ADDENDUM #1

FOR
EV CHARGER UPGRADES AT VARIOUS SITES
FOR
NEWMAN-CROWS LANDING UNIFIED SCHOOL DISTRICT
Bid Time and Date: September 23, 2026 at 1:00 p.m.

EV CHARGER UPGRADES

NEWMAN - CROWS LANDING USD

SCALE: 1/8" = 1'-0"

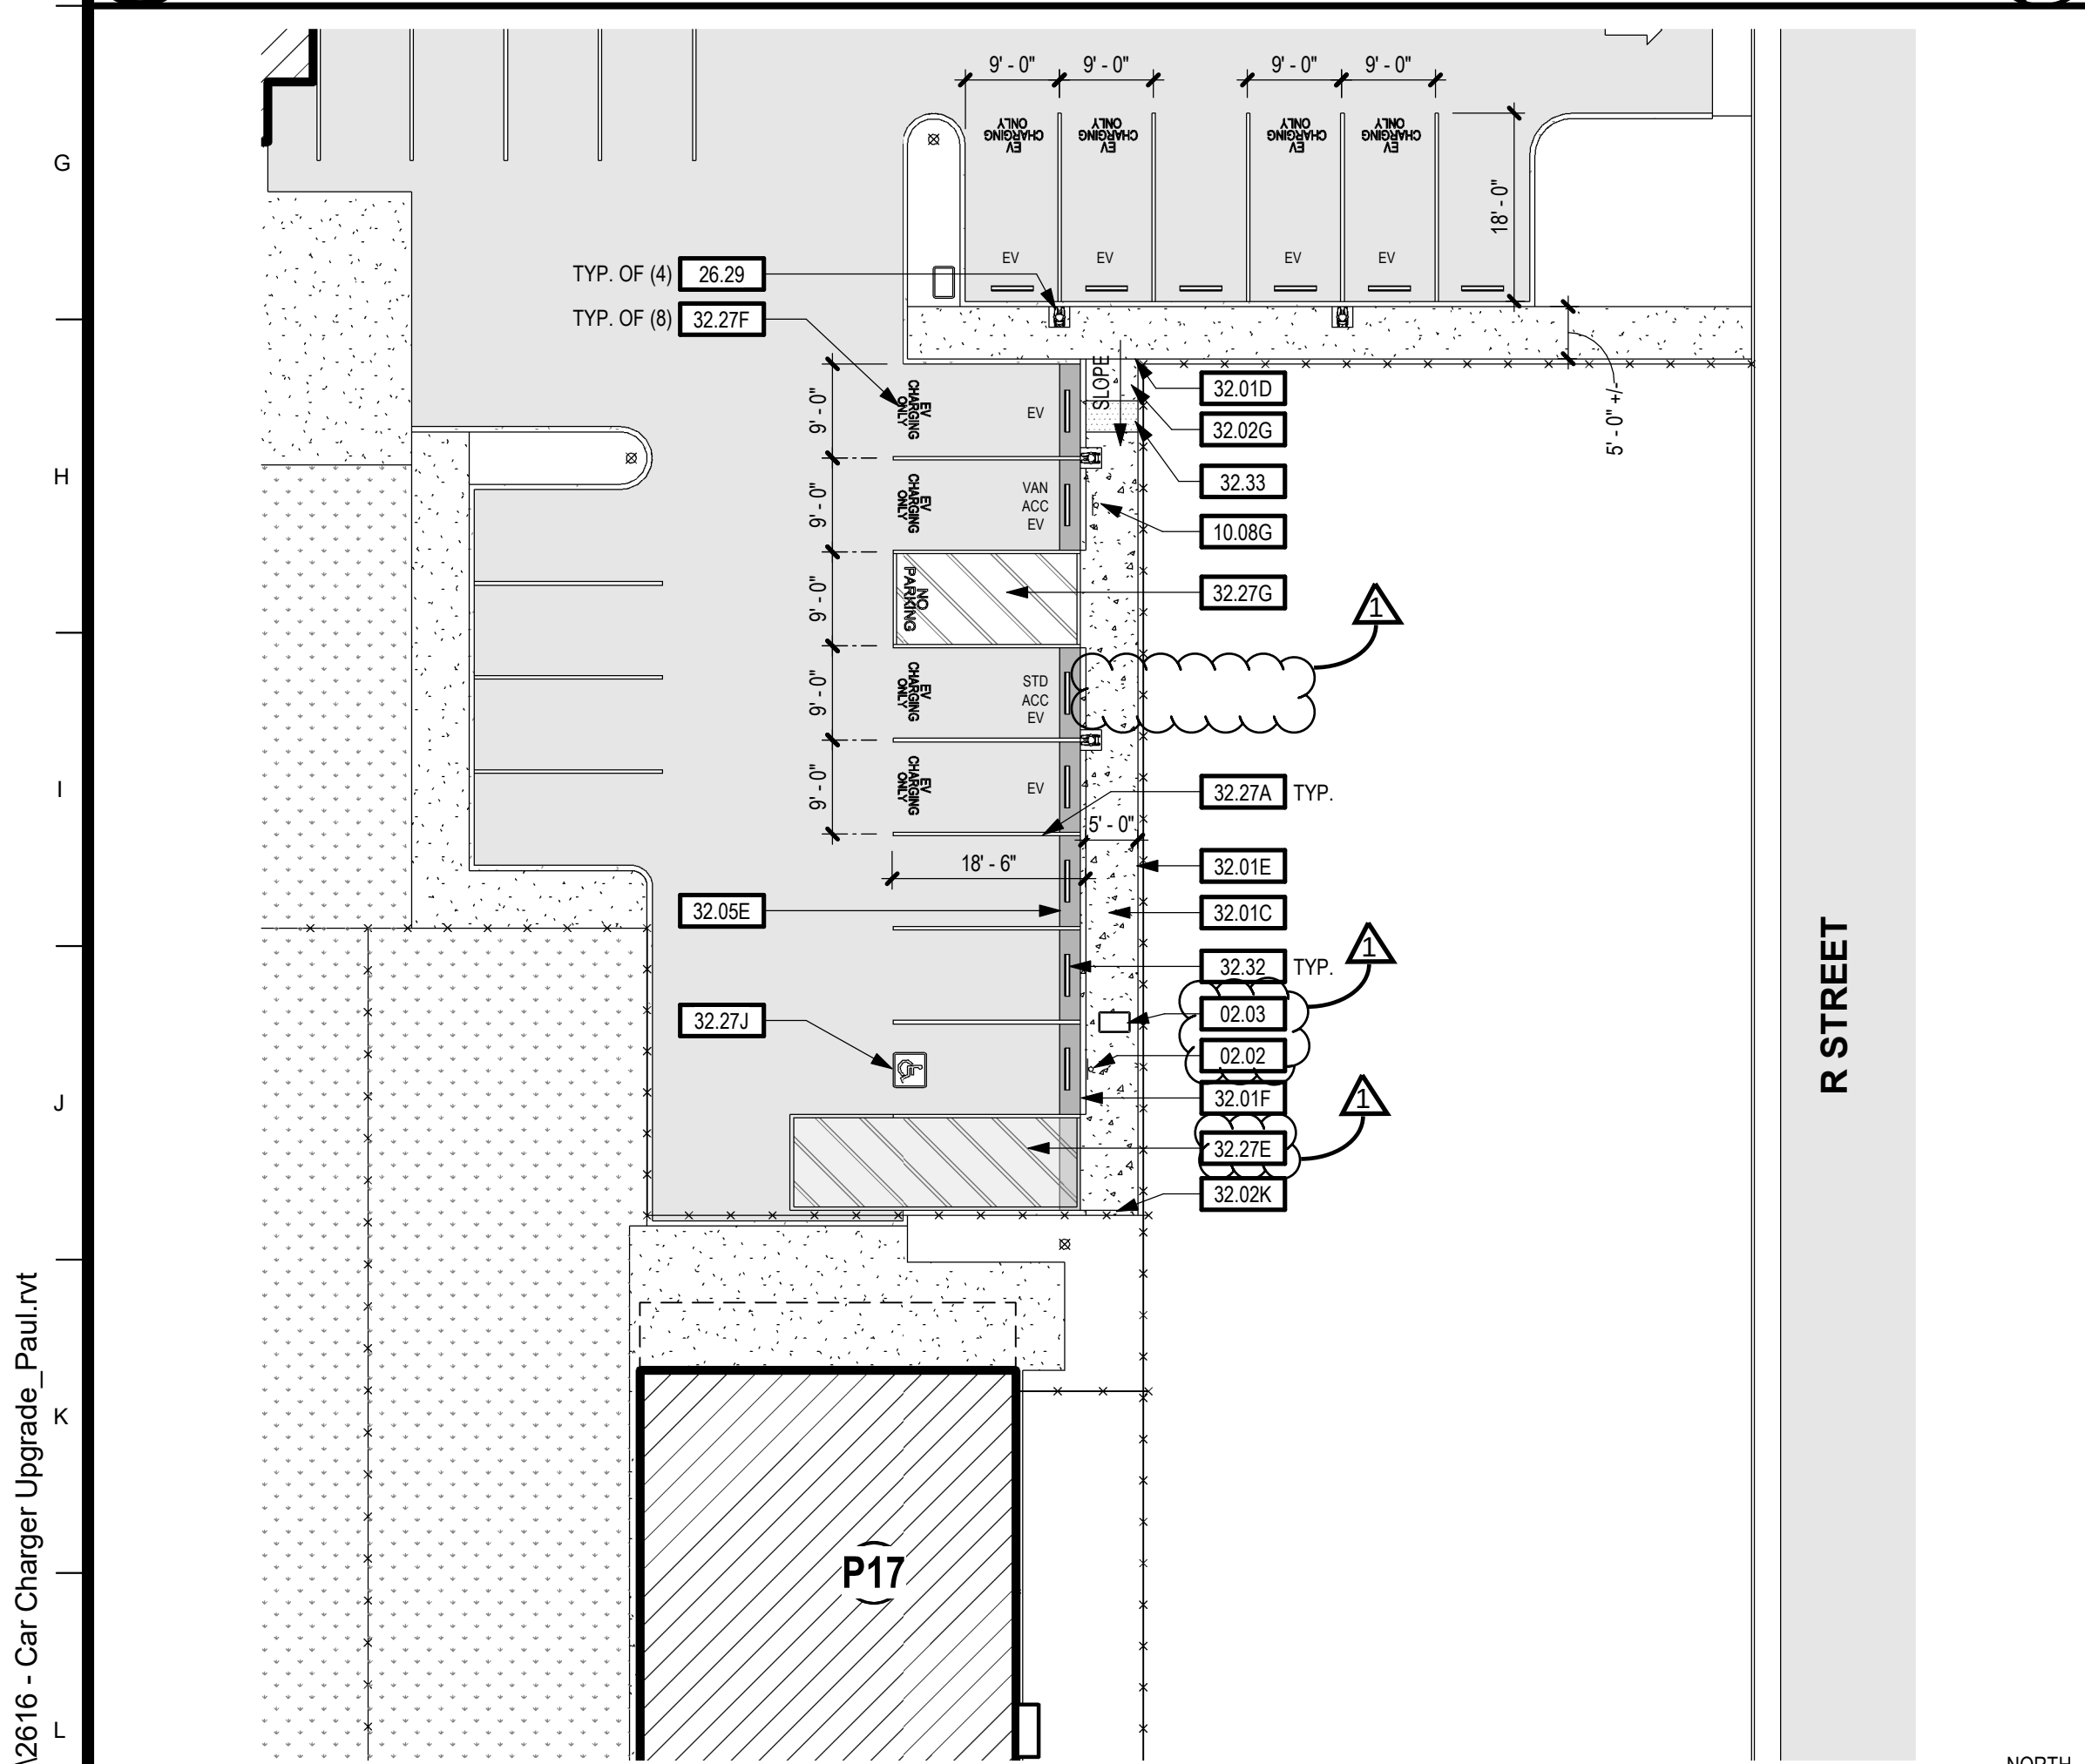
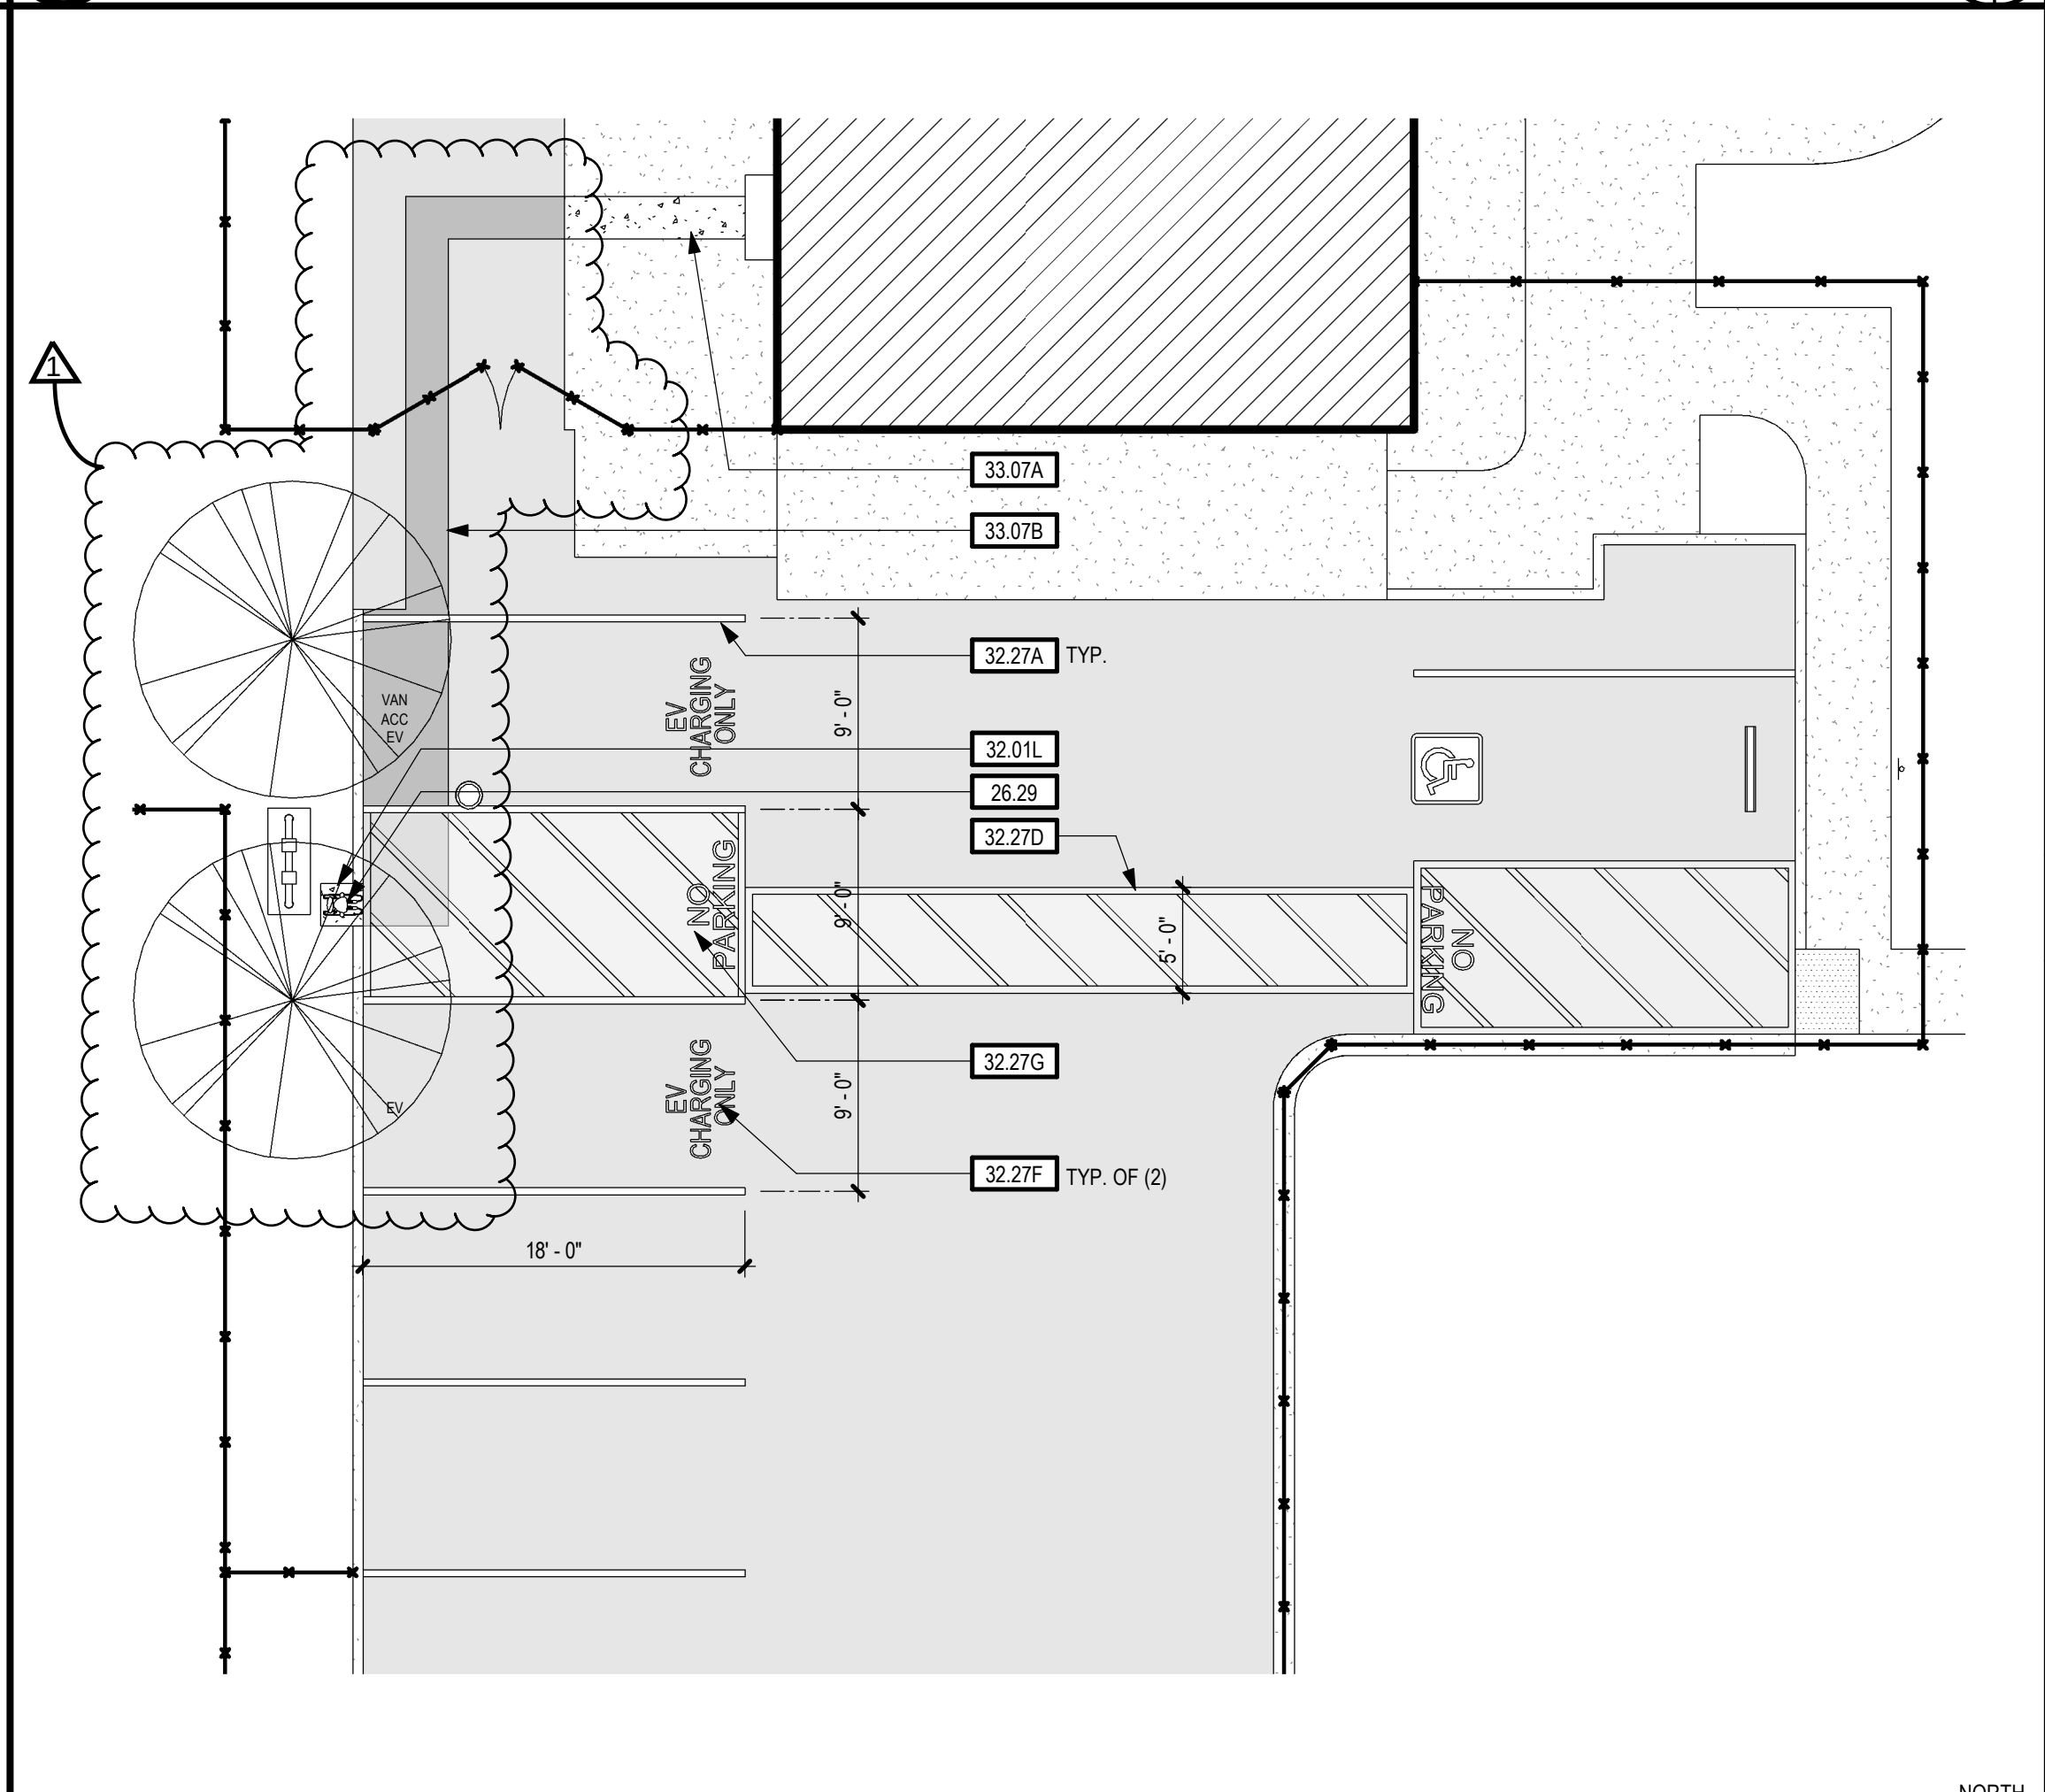
Item 001.:Reference Sheets AS.1 & ES.1 – Electrical Trench Location:
The trench location was moved to avoid trees and existing utilities.

Item 002.:Reference Sheets AS.1 & AS.2 – Accessible Sign Detail:
Detail 14/AS.2 revised for the sign at Hunt Elementary.

Item 003.:Reference Sheet AS.2 – Asphalt Trench Repair Detail:
Detail 15/AS.2 added for the asphalt repair at Bonita Elementary.

SITE PLAN - YOLO MIDDLE SCHOOL

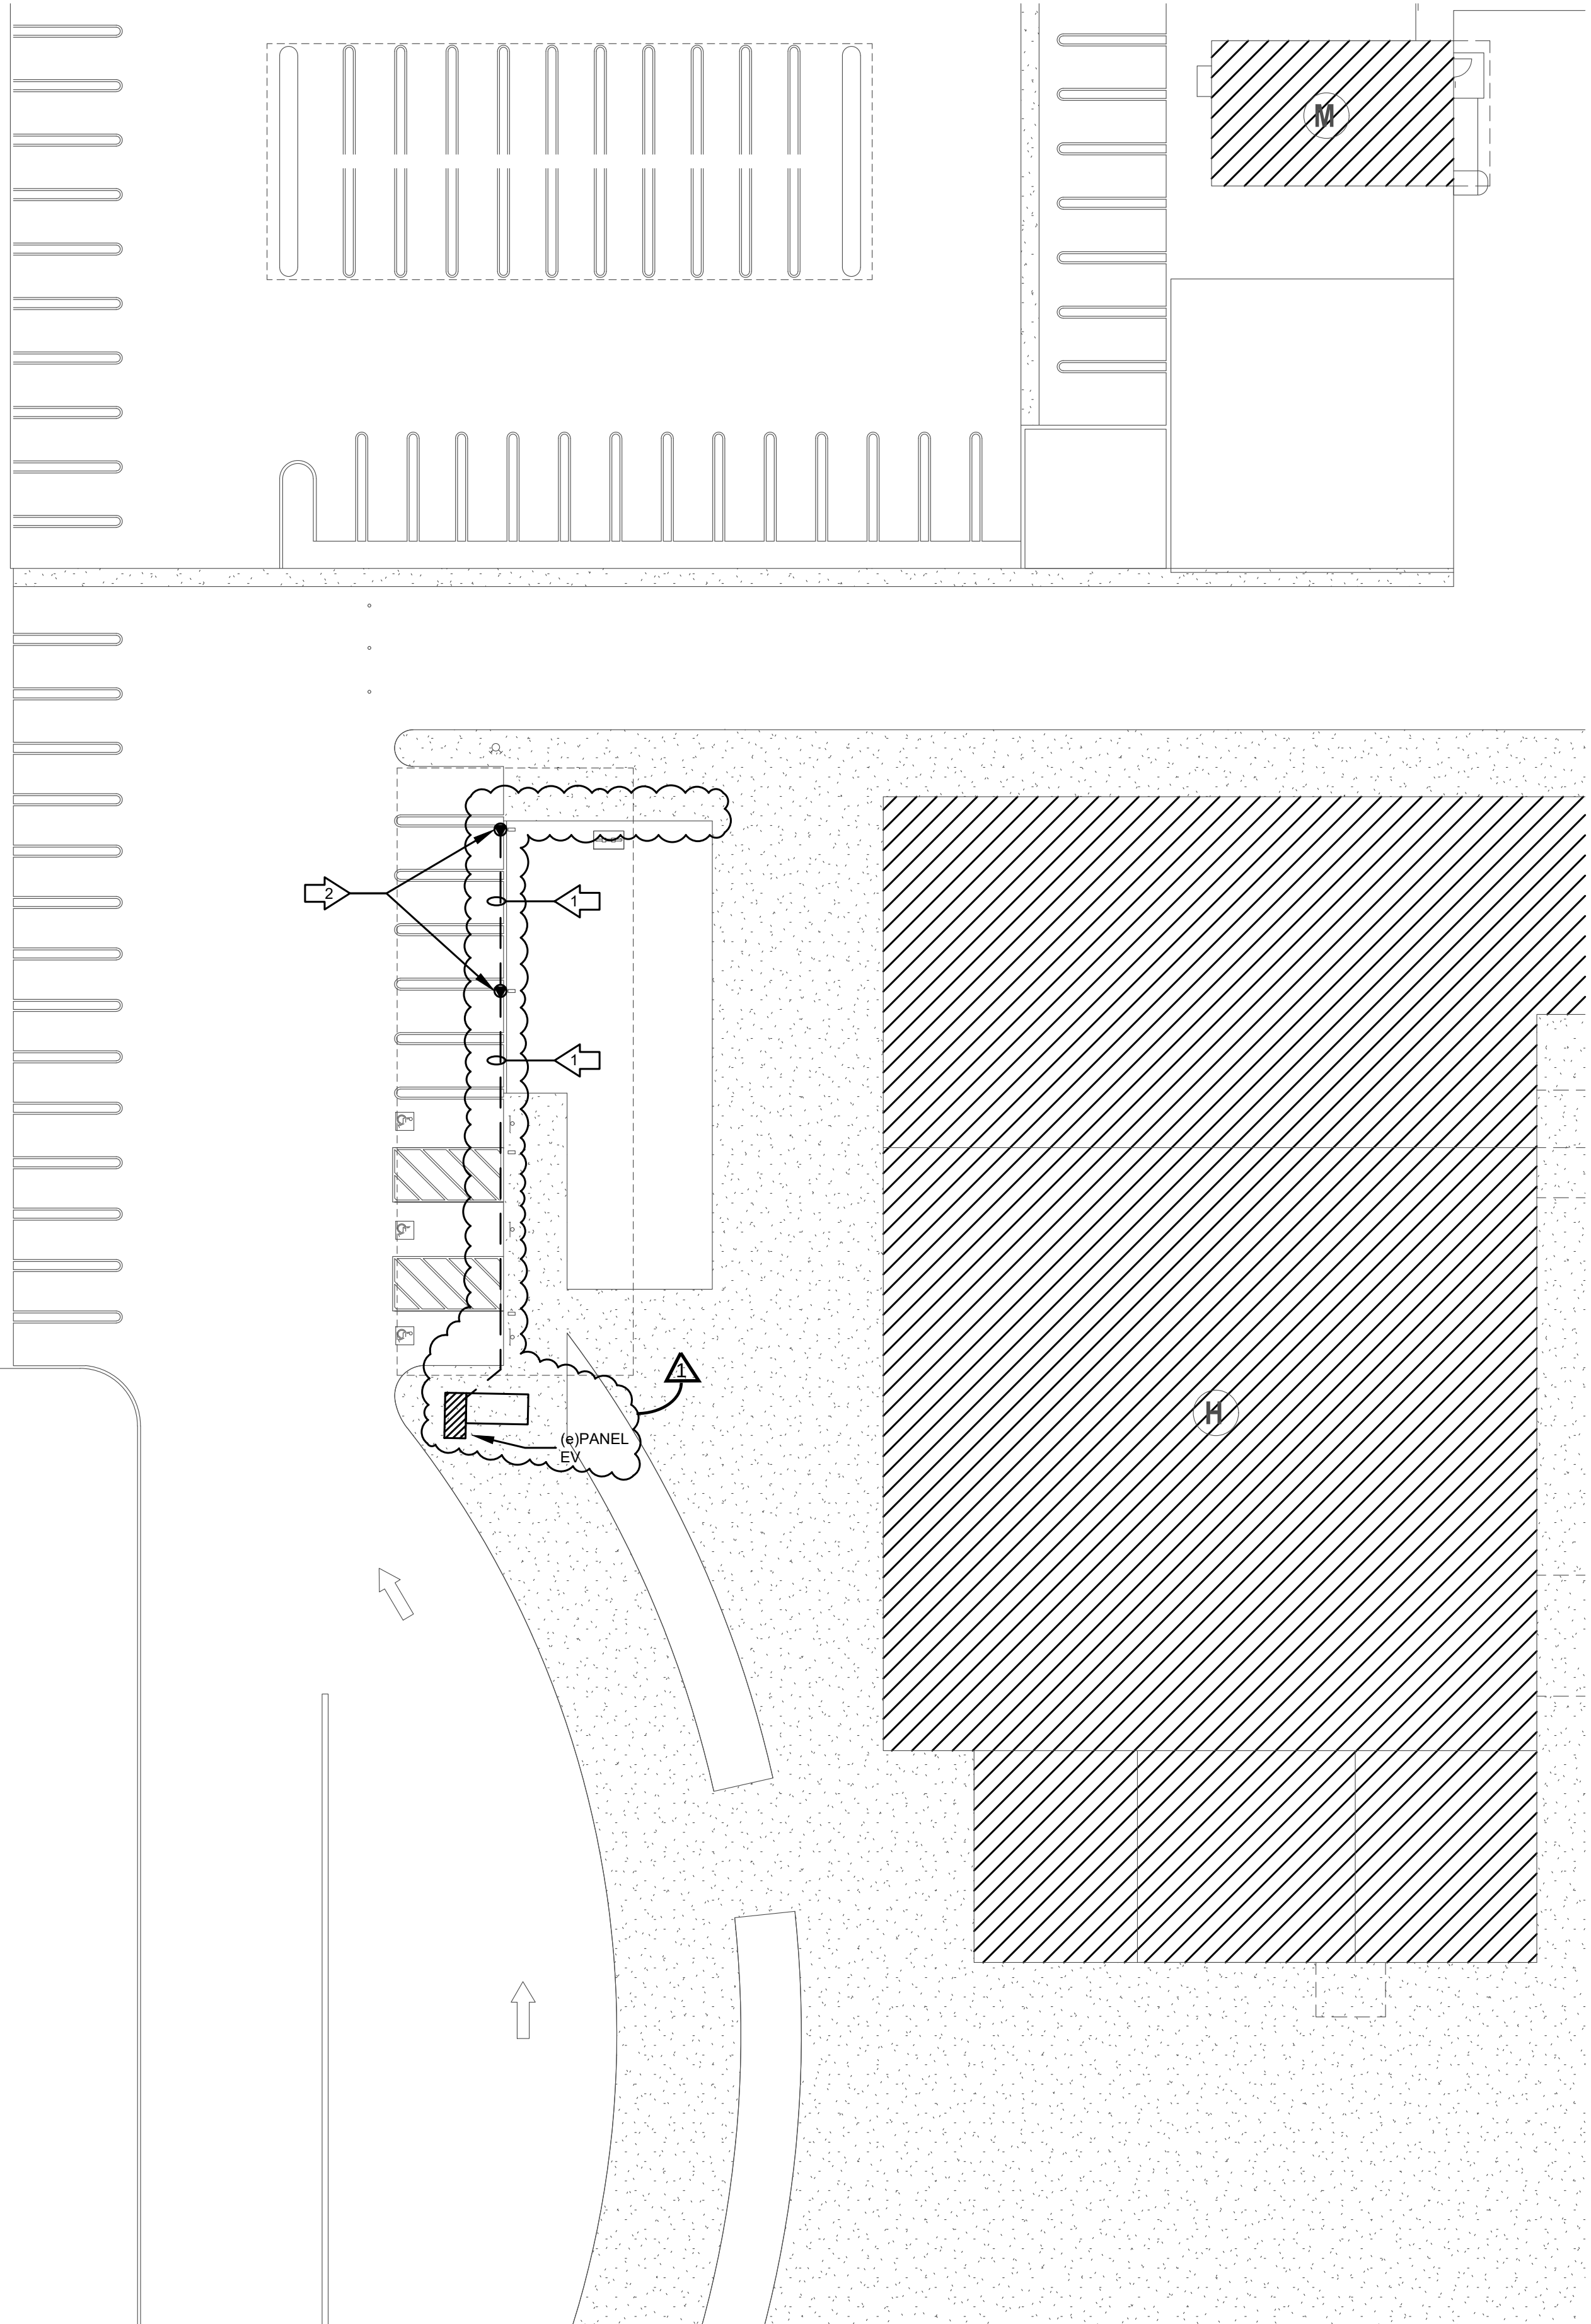
Item 005.:Reference Sheets ES.4 & ES.6 – Revised EV Panel Location:
EV panel location was revised to show existing conditions.
